Town of Duanesburg
Planning Board Minutes
September 21, 2023
Final Copy

Re: Town of Duaneburg
Wishy Wash Site Plan & Special Use Permit Review
Amendment #3 for Engineering Services

As you know, on June 29, 2023, ABD Engineers & Surveyors, the applicant and members of the Town's Planning Board met with NYSDEC to discuss handling stormwater and car wash wastewater at the Ultimate Wishy Wash site. Now, in an effort to satisfy the Planning Board's concern over stormwater discharge to the existing drainage swale located at the southeast corner of the applicants parcel we are proposing an alternative that will send all runoff from the parking area to the existing pond adjacent to the Wishy Wash facility. Runoff from the hill to the north of the site will continue to be diverted from the parking lot via the existing swale and discharge to the Blaise parcel and eventually to the stream that runs under NYS Route 20, as it always has. However, all runoff from the crushed stone parking lot will be treated within the proposed bioretention and overflow from the 10 & 100-year storm events will be conveyed to the existing modified pond. The applicant is proposing to eliminate carwash discharge

SITE PLAN
CAR WASH ADDITION
ULTIMATE WISBY WASH
 WITH WESTERN TURNPIKE

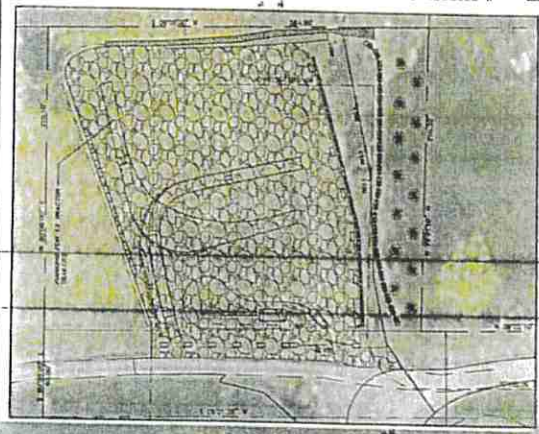
2. ~~The proposed bioretention practice shows a 6" underdrain pipe to daylight discharging to the south of the facility onto lands of the applicant and a 12" HDPE outlet pipe and emergency spillway from the facility are shown exiting to the east onto lands of Thomas into an existing drainage swale which then flows through lands of Chilton prior to joining a stream that flows under NYS Route 20 near Gage Road. We have learned that a similar gravel parking area project was reviewed and approved by the Planning Board last year with a different stormwater design that kept all stormwater discharges on site, however, the design was not constructed as approved and the Town Permit was rescinded. In the December 15, 2021 letter to Dale Warner from Brett Steenburgh, P.E. regarding neighbor property flooding due to prior work performed on the gravel parking area, we located a statement attributed to Jamie Malcolm, NYSDEC Region 4 which said he "suggested that they maintain the existing drainage pattern and drain the pad to the southeast corner and not try to create the swale towards the car wash driveway and down US Route 20 ... as it may cause problems within the highway drainage system and inundate the existing culverts under the driveways of Wren and Chilton."~~ We have not verified this statement with Mr. Malcolm, however, it is in keeping with NYSDEC requirements that the project design must ensure that there is no increase in runoff from a new development project and that there are no adverse effects downstream of the project. We understand that a bioretention practice has been designed to mitigate the offsite impacts of this project, however, since there are own issues with the current drainage pattern, we ask that the applicant provide additional information why the original plan to keep discharges on site are not practical if proper stormwater management practices are put into place to mitigate effects on the Route 20 drainage system and neighboring driveway culverts. Please also refer to our further comments on the stormwater design in the Drainage Narrative section of this letter. We have read the response to this comment in the 10/7/22 response letter from ABD, which did not answer the question above. Additionally, there are still concerns as noted below:

2b. Review of the Stormwater Design Manual (SWDM) shows that Bioretention is an acceptable practice for water quality treatment but is not to be used for water quantity control. An appropriate quantity control practice needs to be included for this project. Please refer to comment 5.e under SWPPP section.

4. The Site Plan shows that the proposed additional bay is encroaching more than 20 feet into the 40-foot side lot setback; however, the Applicant has indicated they have a setback variance. Please provide a copy of the approved variance. We acknowledge that the Applicant has made the request for a copy of the approved variance from the Town, however, we have not been provided this document for review to date.

8. The plans appear to be missing the required grass filter strip between the stone diaphragm and Bioretention practice for pretreatment of direct runoff from the parking lot. The Stormwater Design Manual section referenced for Design Guidance of filtering systems in the applicants response states that "Adequate pretreatment for bioretention systems should incorporate all of the following: (2) grass filter strip below a level spreader or grass channel. (b) gravel diaphragm and (c) a mulch layer." ('Adequate' and 'all' are underlined for emphasis). The grass filter strip will catch fines and keep the stone diaphragm from clogging and becoming ineffective.

9. The Drainage Narrative in Appendix E of the SWPPP, page 3, states that "Two new trenches are proposed along the edge of pavement that will collect stormwater from the asphalt surface. There is a negligible difference in runoff volume generated from the existing impervious crusher run stone and proposed impervious asphalt." The plans show a 12" pipe outlet from the stone trench without any treatment practices associated with this concentrated flow. The plans and SWPPP should be revised to include the proper stormwater treatment for a redevelopment project in this area of the site. We disagree with the applicant that this is not a case of redevelopment. As stated in the SDM in Chapter 9, redevelopment includes reconstruction of existing impervious surfaces. Please review section 9.2.1 of the SDM and accordingly size or describe the WQv practices to meet the requirements.

10. Please label the proposed stone swale along the eastern edge of the parking lot on the site plan.

11. Please indicate the swale which the 6" underdrain feeds into on the site plan. The swale is defined by the existing contours shown.

See revised stormwater plan. We are proposing to partially fill in the existing pond with clay excavated from the bio retention area. By doing so, more than adequate storage will be provided for the 100-yr storm event. An outlet control structure is proposed with a 2-inch PVC discharge to slowly release the 100-year storm at slow flow rate of 0.16 cfs.

Not required. "Should" is defined in the manual as meaning a recommendation. Also, the detail from the manual you provided in your letter shows the stone diaphragm upstream from the grass filter strip, therefore, having no benefit on the stone diaphragm.

This is not a case of redevelopment; it is just a building addition. However, a 2'w-by-2'deep stone diaphragm trench is proposed at the westerly end of the Wishy Wash exist drive and along the edge of gravel nearest the pond to handle stormwater runoff, as depicted on the enclosed plans.

The existing stone swale is labeled on the enclosed plans. There is no proposed stone swale on the plans.
